The World's First Open Source Gutter Leaf Eliminator

W, D, H: 144.0, 146.0, 155.8 mm

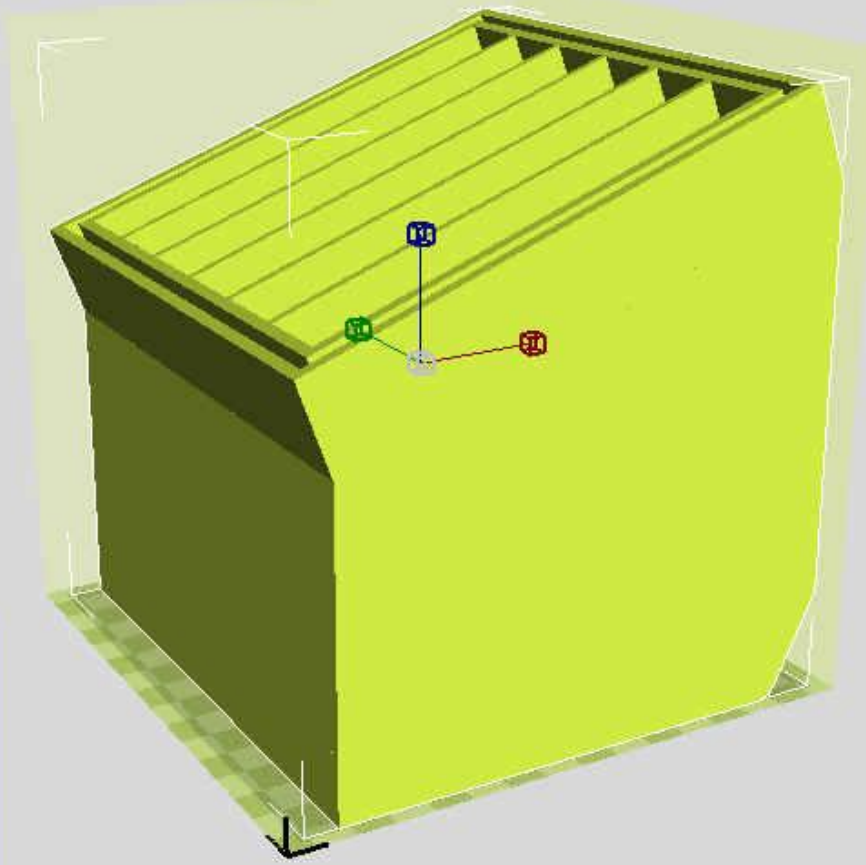
97% scale in Y to make it fit

- Takes 11 hours to print
- I'm concerned the grate will fall
- Increase the grate angle - by making the slats irregular:
 - Thicker on bottom
 - Thinner on top

- Top of grate remains the same
- Move the hole all the way to the bottom
- Move hole slightly left to allow for the steeper grate angle
 - The permeable area of the grate is already a less than the pipe. If i thicken the bottom of the slats it will be even worse.

- I can move the hole to the bottom, but that gives only 0.175"
 - The requested changes need a huge redesign, and are more complicated to do. It may take the whole next week to do them. And even then, I do not think that we will have a superior model, but just a workaround for the Luzbot mini.

- I would like to focus to make a model that most people can use, (8" print bed with 9"-9.5" print height), and make a decent model from the start.
 - Even the latest design restricts the maximum flow that the 3" pipe can take (calculated for a minimum pressure, since the fall is a minimal), so larger area of grate is needed

- The hole will not be printed smooth and round and it will definitely leak, so you need sealant anyway.

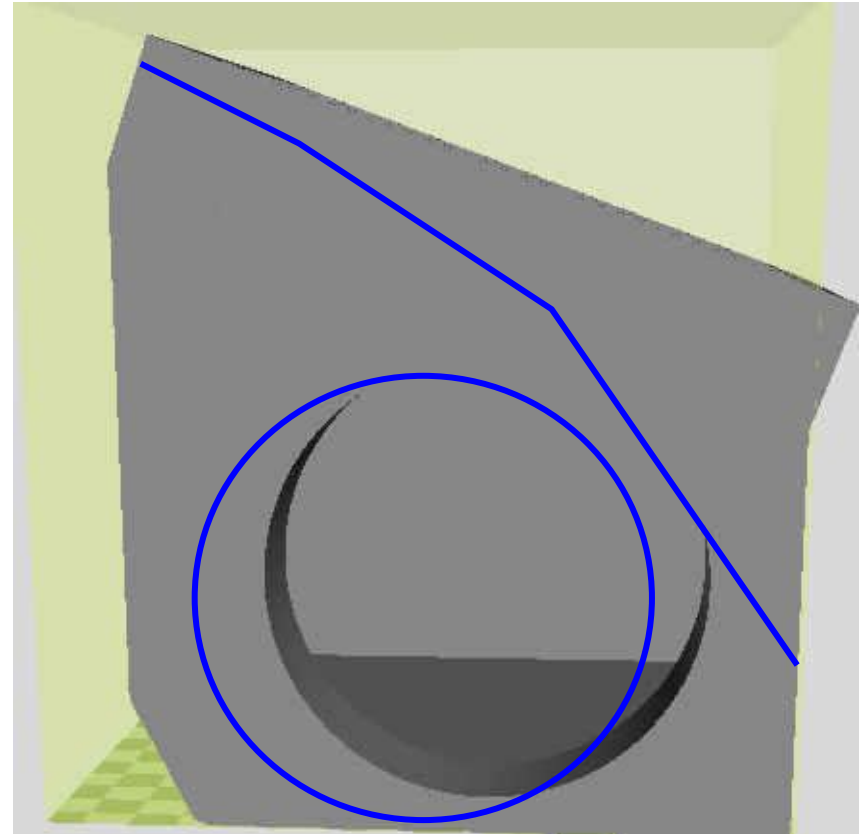
My suggestions are:

- 1) Make the gutter wider, towards the 8" width,
- 2) Make the grate a separate piece that snaps on the main body even without sealant, **OR** eliminate the grate. You do not really need a 3D printed grate. The aluminum screen can hold the leaves. Even small rocks will bounce off. But if you need that better support why not use a wire mesh below the screen? I can add a "step" that can accept a 1/16" thick piece of mesh so the screen will not be ripped.
- 3) Increase the back wall height but not too much that the water will run off in a heavy rain. Keep the industry standard slope -balance between self
